August 24, 2023

ADDENDUM NO. 1

Notice to All Persons and Firms Proposing
to Submit a Bid or Furnish Materials for
James S. McDonnell Blvd. Bridge No. 164
St. Louis County Project No. AR-1518
Federal Project STP-4900(640)

J.S. McDONNELL BLVD.
 BRIDGE NO. 164
 (SHEET 2 OF 3)
 PLAN AND PROFILE SHEET

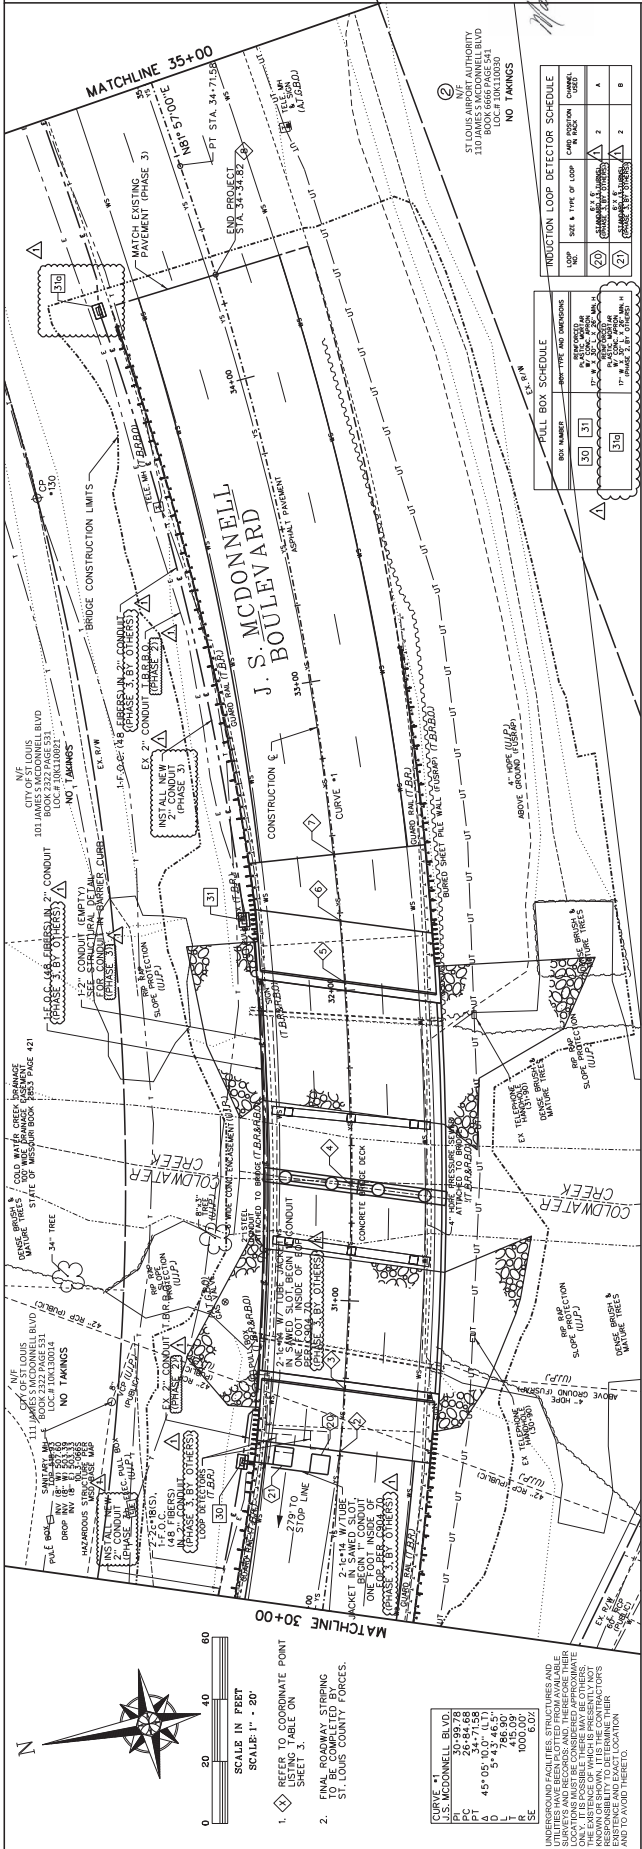
There are 2 ea 6x6 loop detectors shown on Plan Sheet 8 of 63 to be installed at 30+50+- West Bound Lanes with 2 ea 18/2 Shielded Cables installed back to existing controller. How are these items to be paid for?

This will be completed by the County's Signal electrical contractor and is not a part of this contract.

J.S. McDONNELL BLVD.
 BRIDGE NO. 164
 (SHEET 3 OF 3)

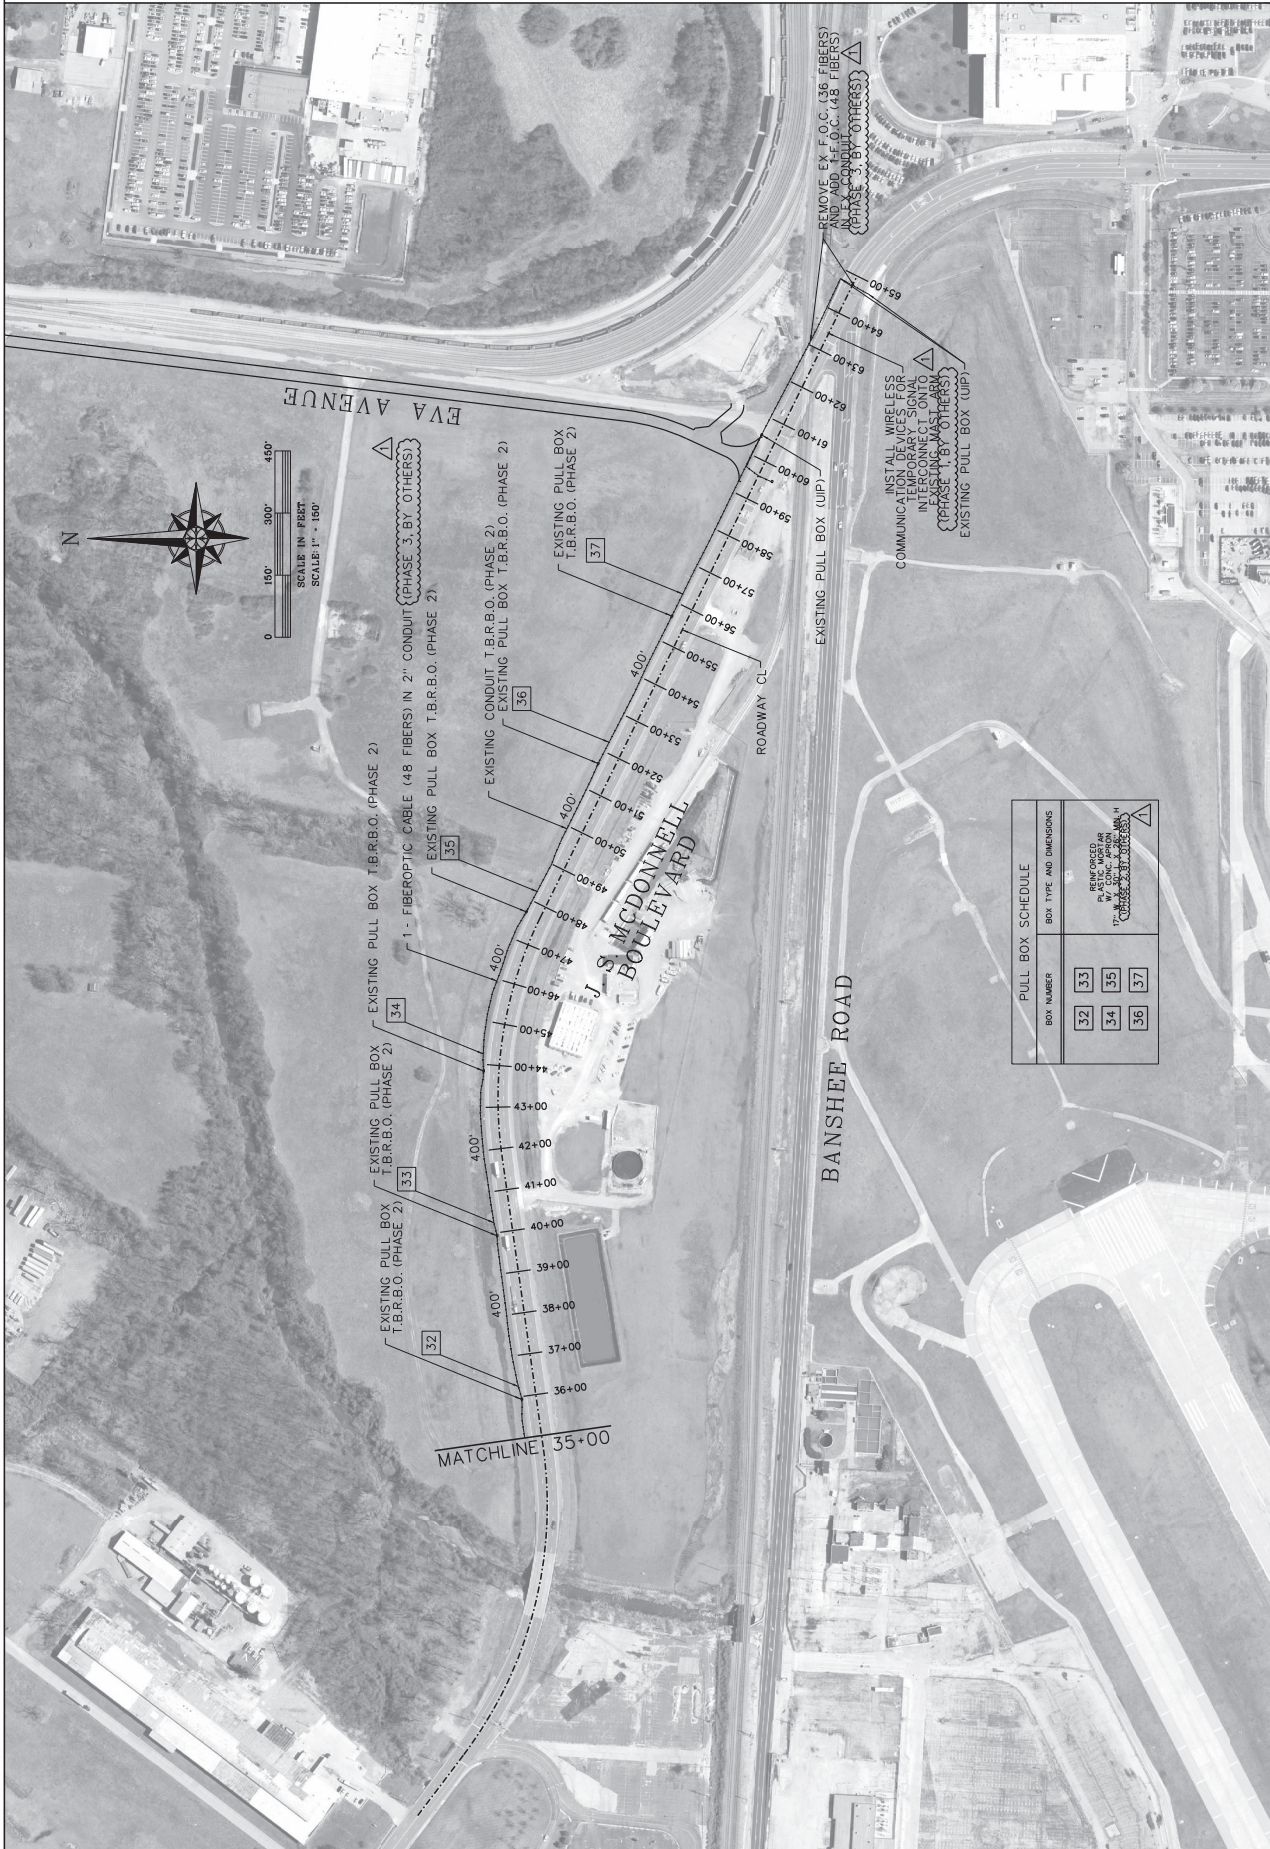
Pay Item 904-52.00 (2" PVC Conduit) is to be installed from 27+75 to 60+50 (3275 LF) but no mention of the Pull Boxes (32 thru 37) being installed or a pay item set up for these(Sheet 9 of 63).

The 2" conduit and pull boxes will be removed and replaced from 27+75 to 34+35 under this contract. Pull boxes 32 to 37 will be removed and replaced by the FUSRAP contractor.
